**SODERHOLM AND ASSOCIATES BUILDING**  
ADDITION SITE PLAN

**GRADING AND EROSION CONTROL PLAN**  
CITY OF RAMSEY, MINNESOTA

UTILITY.pdf V2 - Changemark Notes ( 5 Notes )

1 LANDSCAPE PLAN  
 L1 SCALE: 1" = 30'-0"

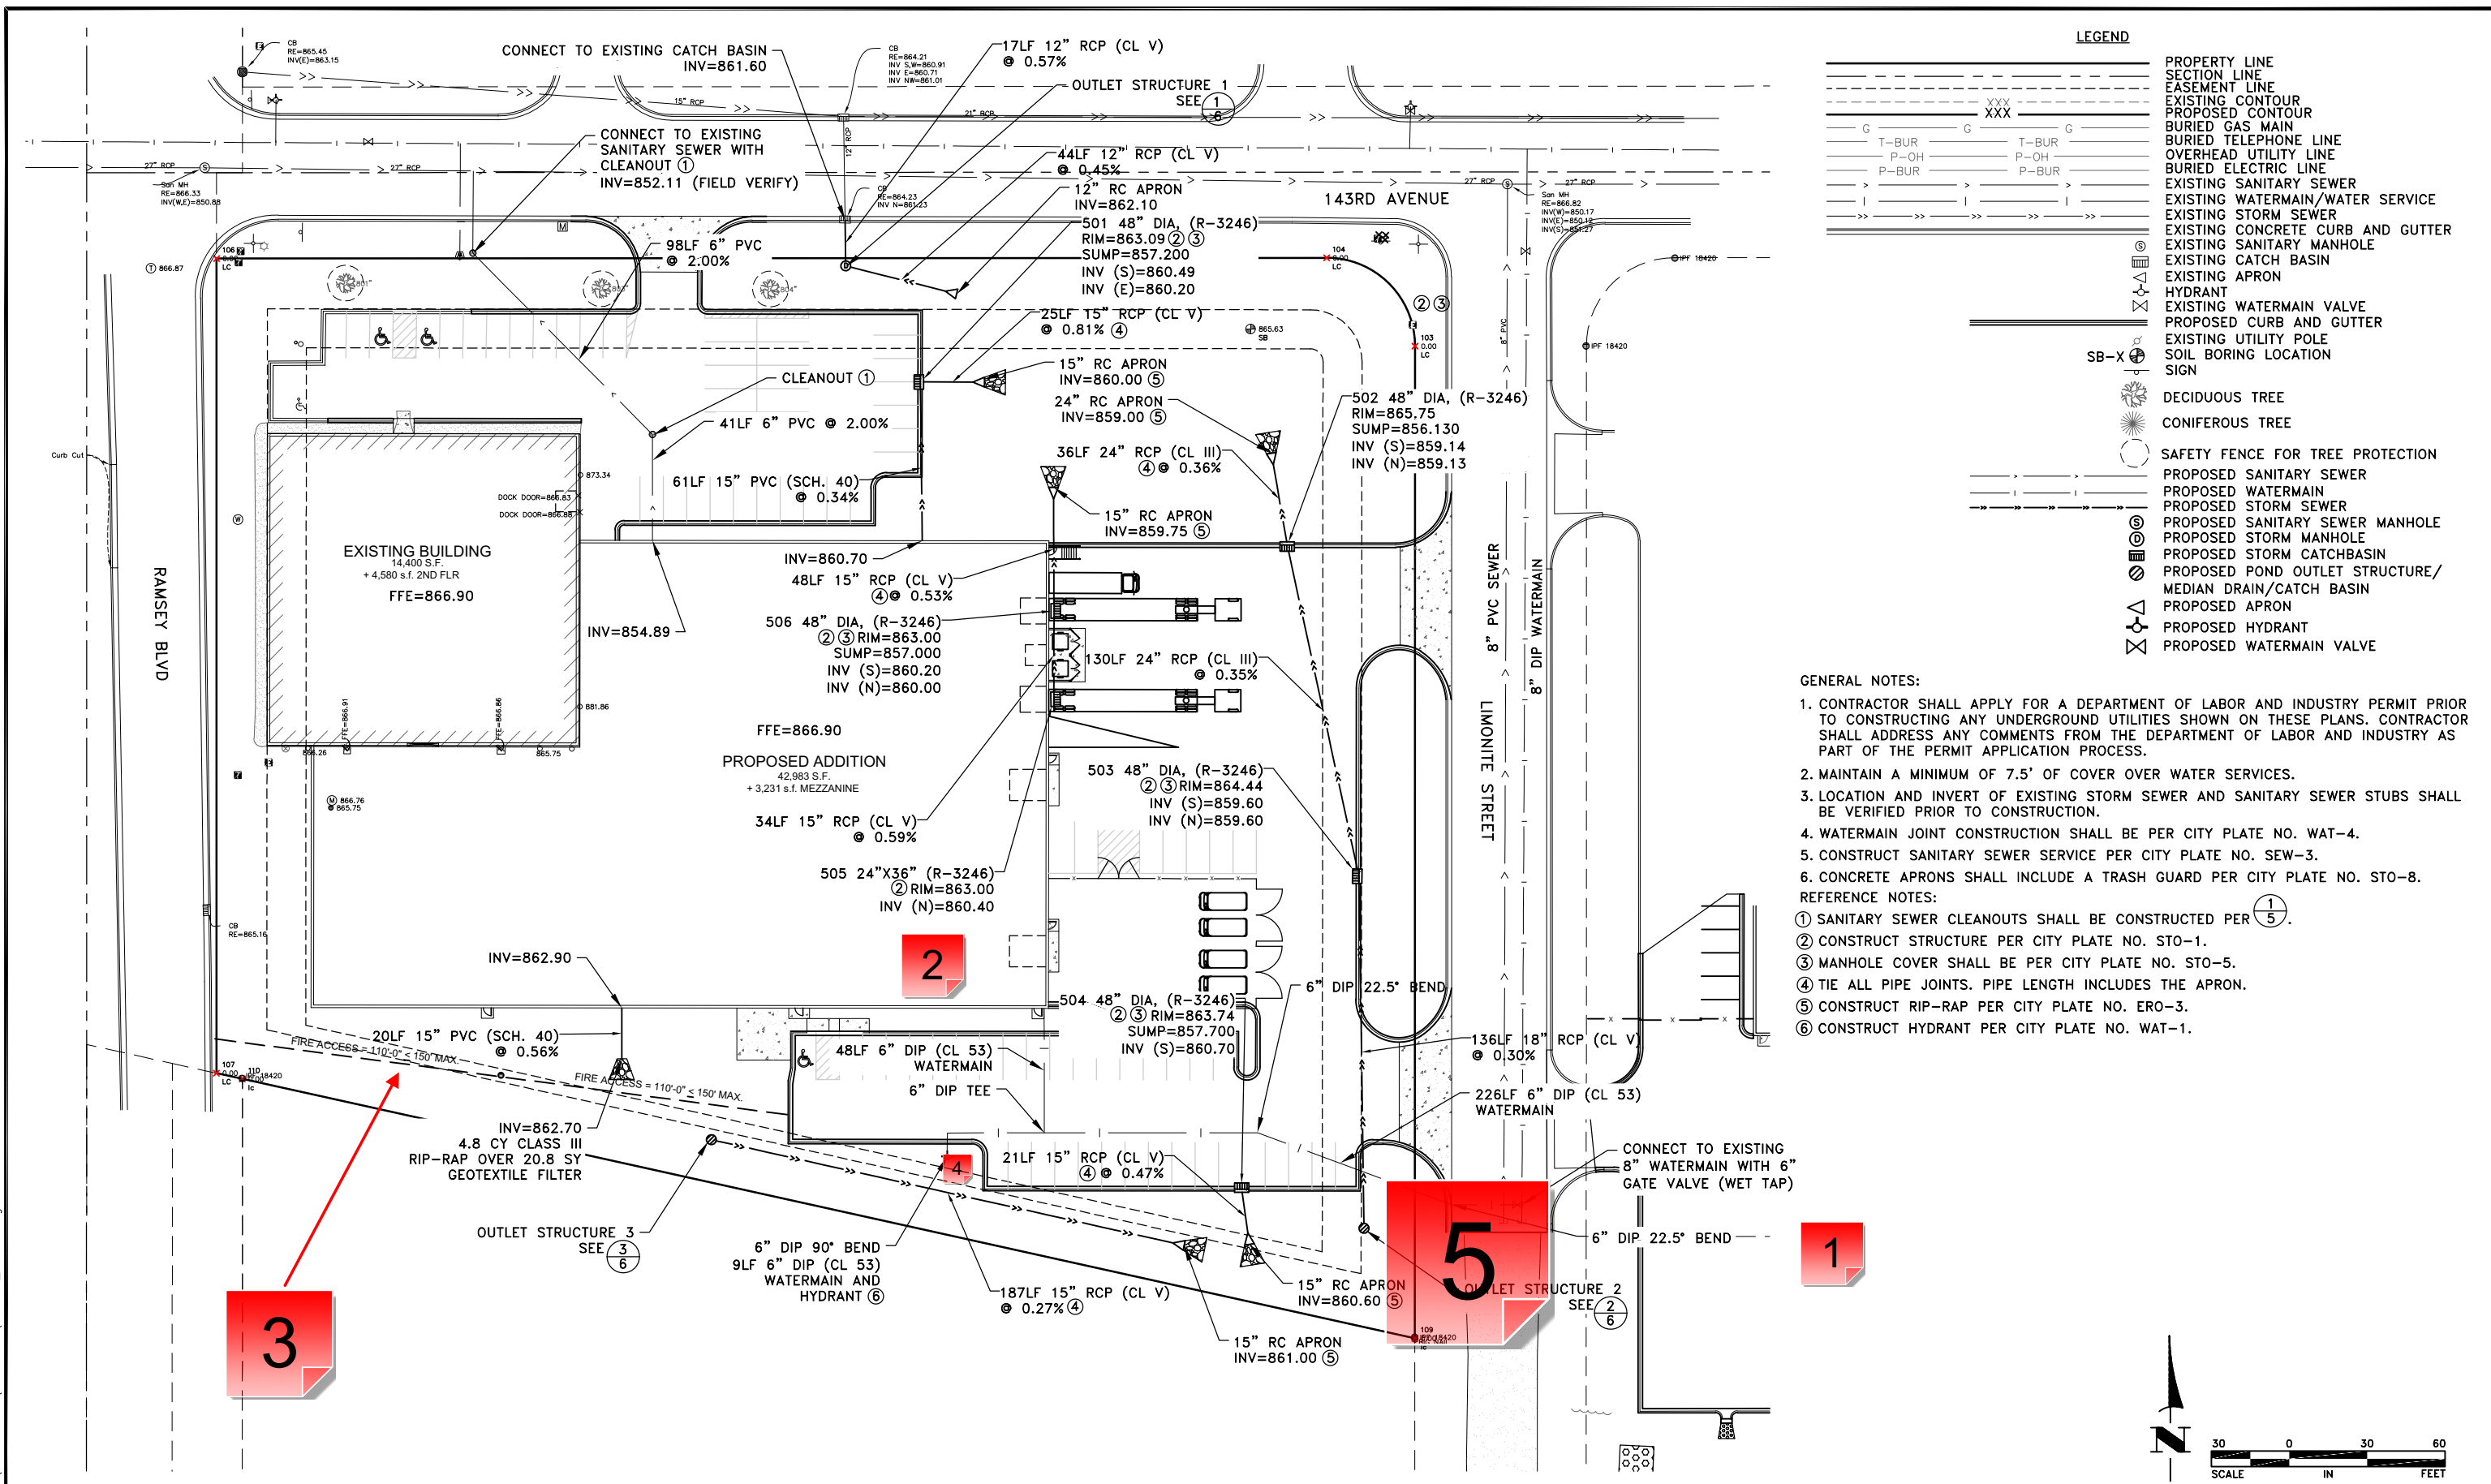
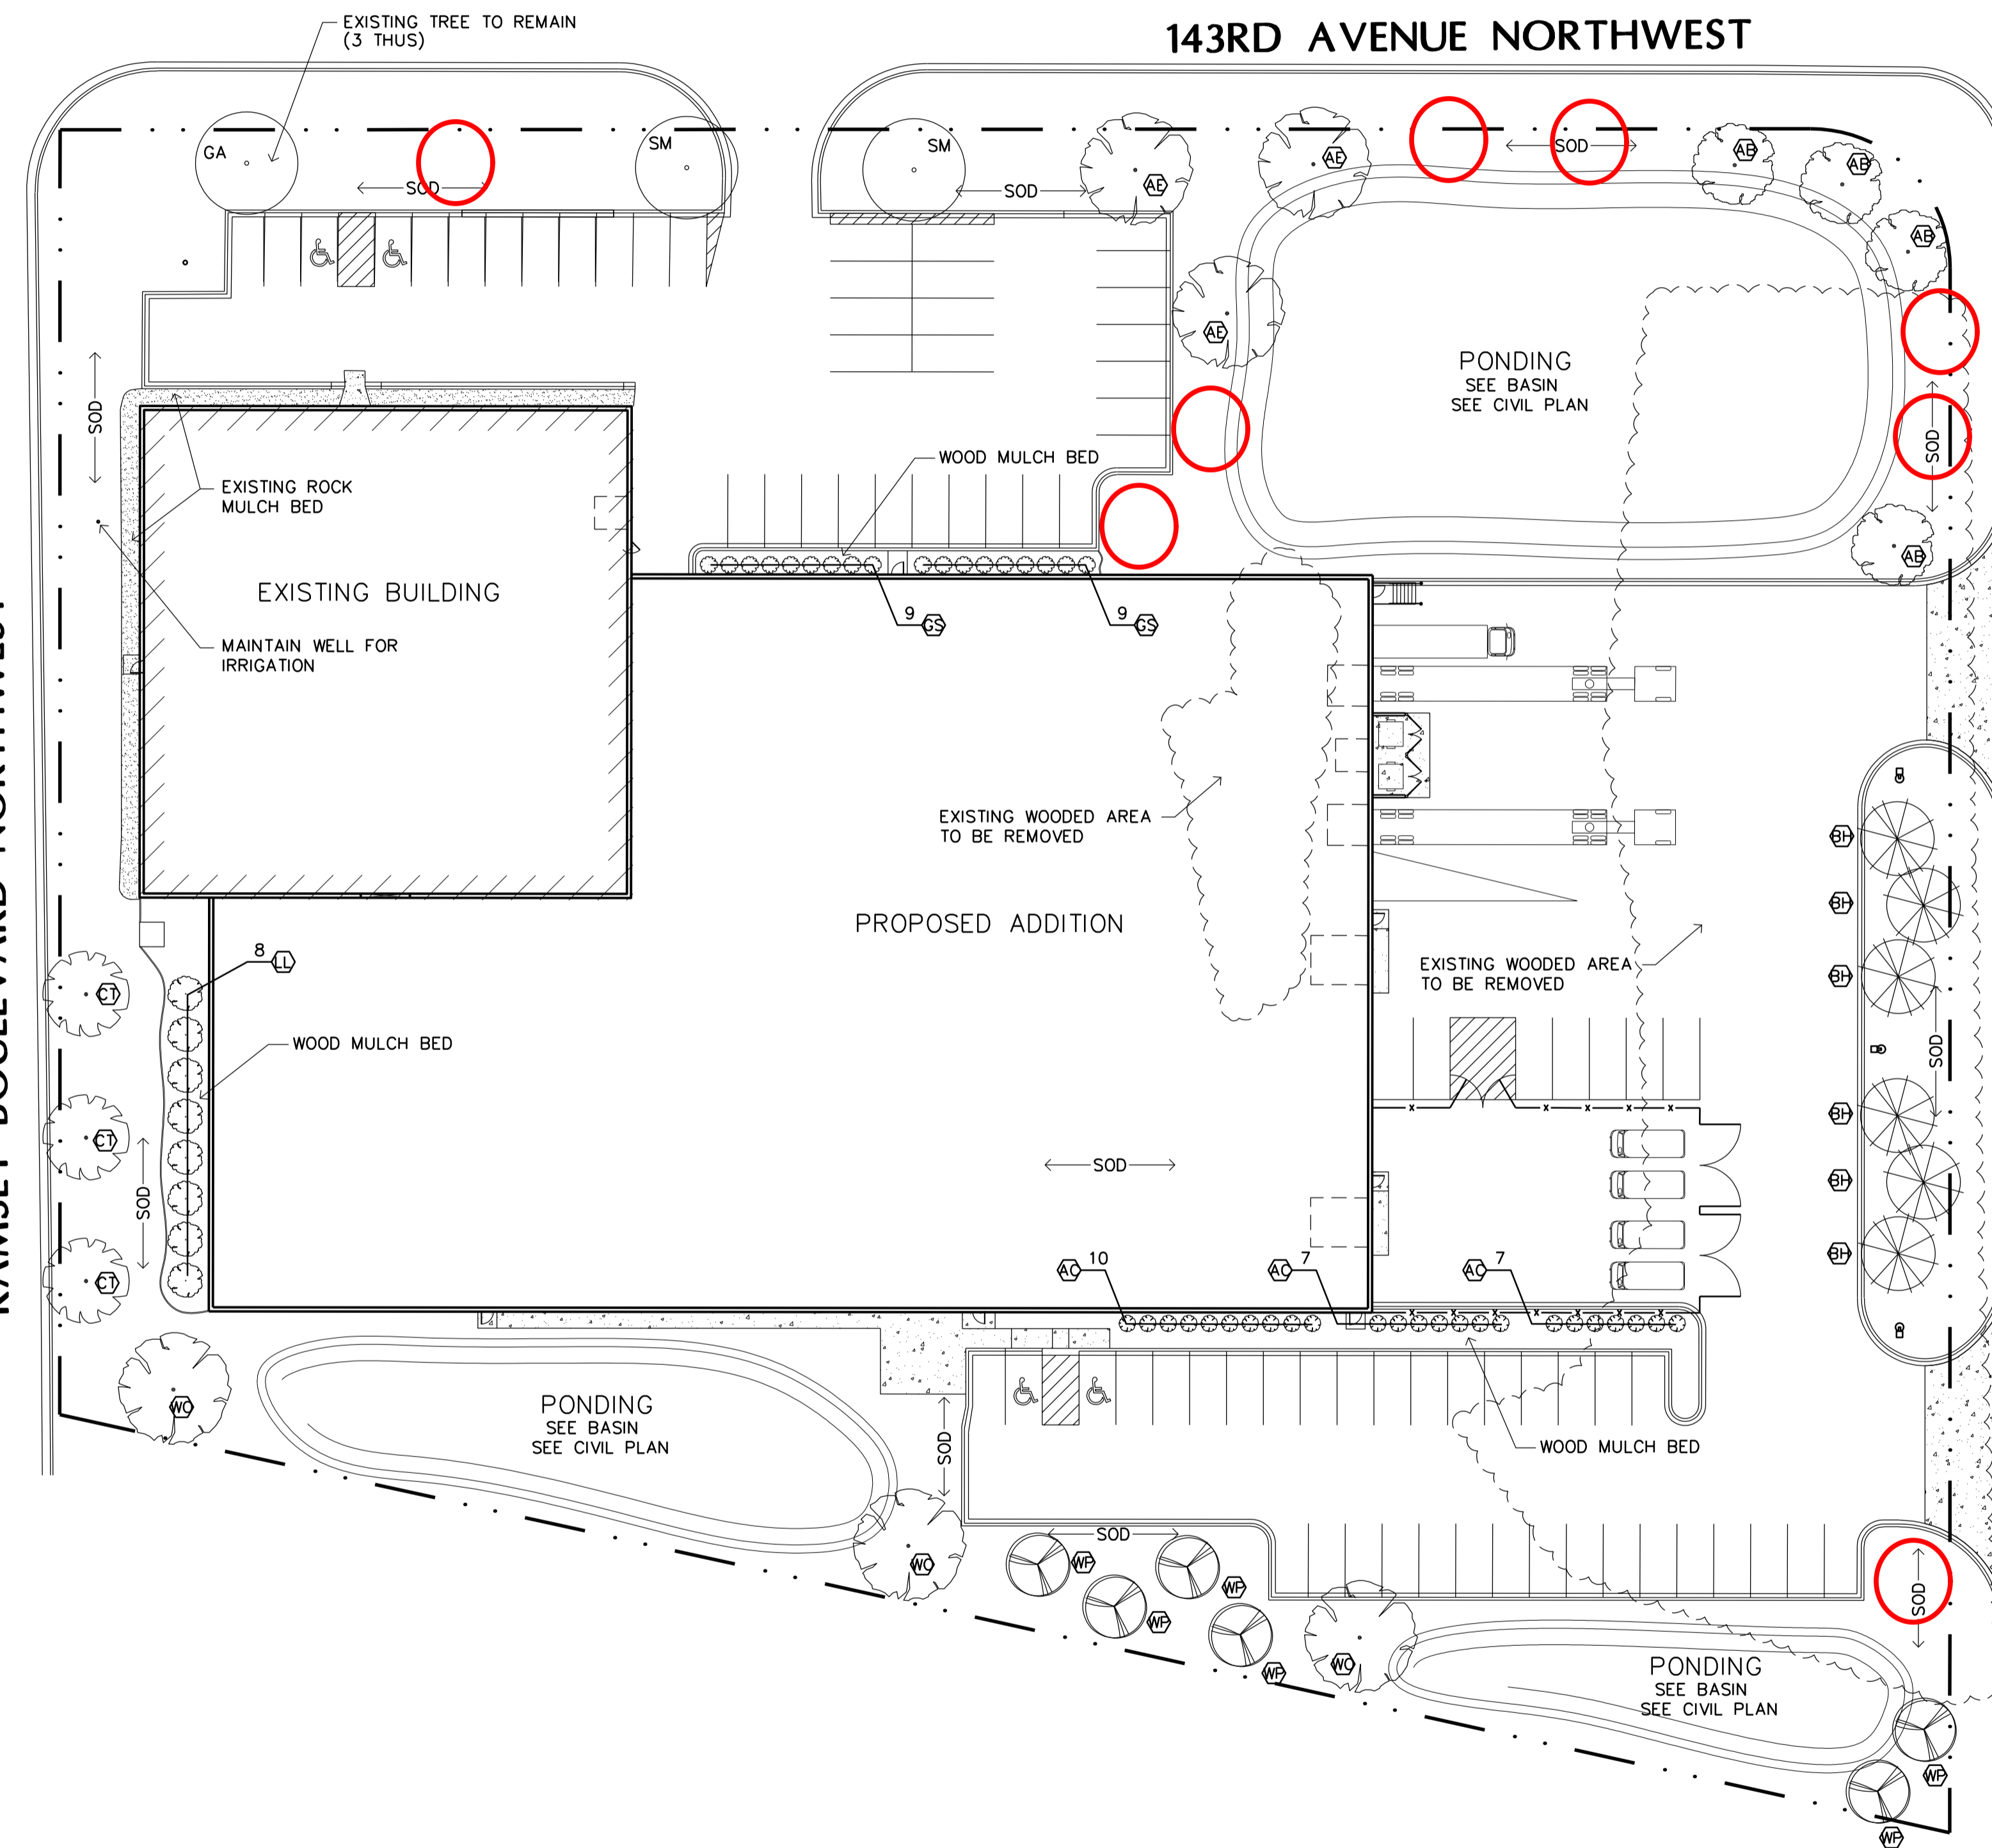
## 1 - Reforestation

Based on the tree preservation standards of preserving or reforesting 30% of the existing significant tree DBH inches, a minimum of 112 inches must be planted (579 inches x 30%).

This plan only provides for 62.5 inches of new plantings. Additional trees should be strategically added to the plan as indicated by red circles. Assuming these additional plantings are each 2.5", that is an additional 20 inches, for a total of 82.5 inches of reforestation.

That would mean a payment into the community forestry fund of \$3,625 ( $112 - 82.5 = 29 \times \$125$ ), which will be addressed in the Development Agreement.

Additional plantings could be added to the plan (for example, spacing between proposed trees could be reduced to accommodate more plantings), which would further reduce or potentially eliminate the 'restitution' payment.
